Access Compliance Report

Public Rights-of-Way

(Curb Ramps)

| Intersection ID: 10021247 | Main Street: BIRNEN_DR | Cross Street: N/A | Location: NW |

| ADA ID: 62A01865D8CC | Ramp Type: PerpDiag | Initial Pass/Fail: Fail | Overall Compliance: No |

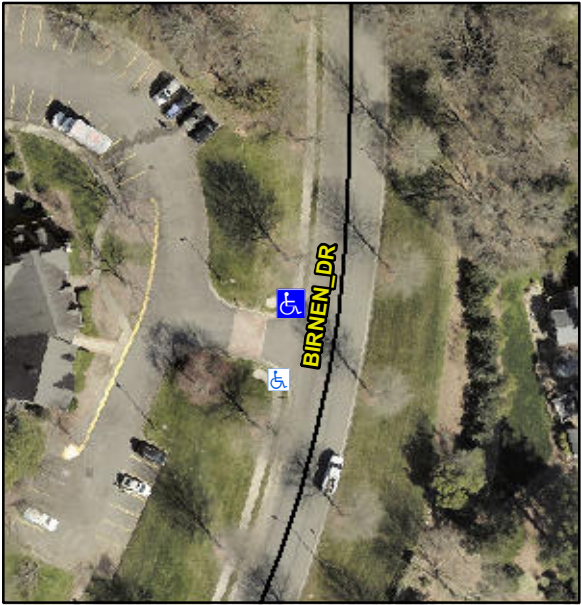
| | Remove & Replace Curb Ramp With Two New Directional Ramps or Equivalent. | | N/A | Ramp Length (in) | 61.0 | No | Ramp Slope (%) | 9.1 |
| <p>Surveyor Notes:</p> <p>N/A</p> <p>PROW/ADA:</p> <p>Not Found, R304.2.2, R304.5.3</p> | | | Yes | Ramp Width (in) | 51.0 | No | Ramp XSlope (%) | 13.1 |
